15 August 2017

OUR REF: 476207 - 01000

**Re: 3071 Riverside Drive – Canoe Bay Development
 Transportation Impact Study – Addendum #1**

Figure 1: Total Projected 2024 Traffic Volumes

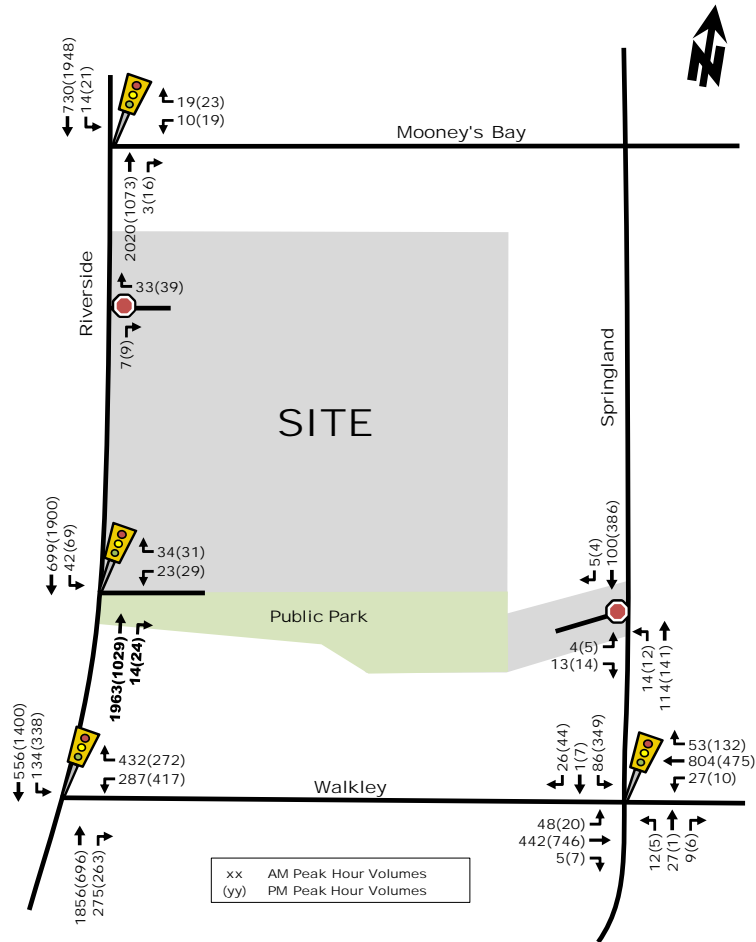
With regard to the relocation of the daycare and the increase in vehicle parking supply along Springland Drive, the resulting vehicle trip distribution will be similar to the original TIS/CTS. As shown, approximately 20 two-way veh/h are projected to travel along Springland Drive to/from the proposed parking lot, which equates to less than 1 vehicle every three minutes along this local road.

The removal of the right-in/right-out vehicle access to the underground parking lot will increase vehicle traffic at the proposed signalized access and the right-in/right-out driveway connection to Riverside Drive at the north end of the site. In addition, it will likely reduce the number of U-turns at the proposed signalized access (Riverside/Site). The revised trip distribution is illustrated in Figure 1. Based on this redistribution of vehicle traffic, the resulting signalized access to the site is projected to operate acceptably, as shown in Table 1.

OVERALL SITE PLAN

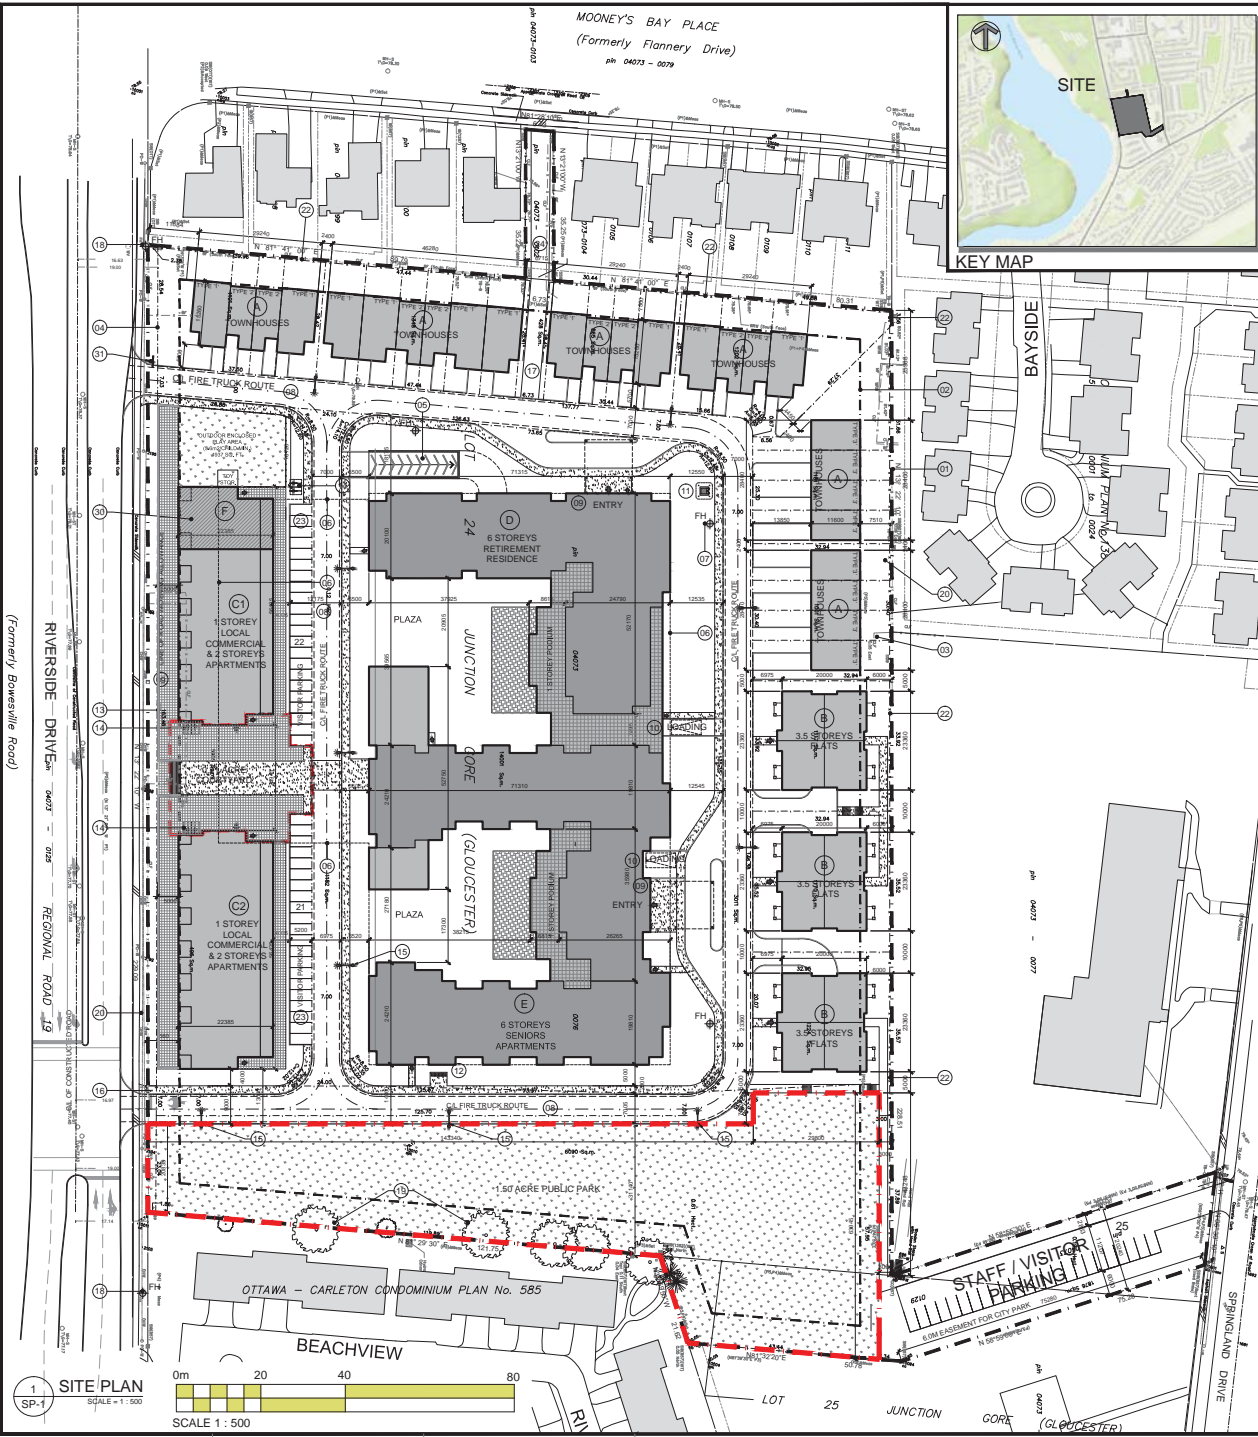
This Addendum to the original Community Transportation Study/Transportation Impact Study (CTS/TIS) has been prepared to identify the transportation-related changes to the Site Plan and address any impacts these changes will have on the overall results of the original study. The revised Site Plan is attached and includes the following transportation-related changes:

- Removal of the right-in/right-out driveway connection to Riverside Drive which provides direct access to underground parking garage;
- Slight decrease in residential units from 627 to 617 units;
- Slight increase in parking from 434 to 460 spaces;
- Relocation of the day-care facility from Springland Drive to ground floor of the northwest building; and
- Increase parking lot size on Springland Drive from 11 spaces to 25 spaces (staff parking).

With regard to the change in residential units, this will have a negligible impact on the trip generation analysis from the original report. The revised vehicle parking supply for the entire site meets the City’s By-Law requirements. It is noteworthy, however, that for Building Type ‘B’ (apartments) and ‘C’ (mixed-use), the parking is slightly undersupplied and for Building Type ‘D’ and ‘E’ (retirement home) the proposed provided parking is over the minimum requirement by approximately 90 spaces. This is outlined on the revised Site Plan.
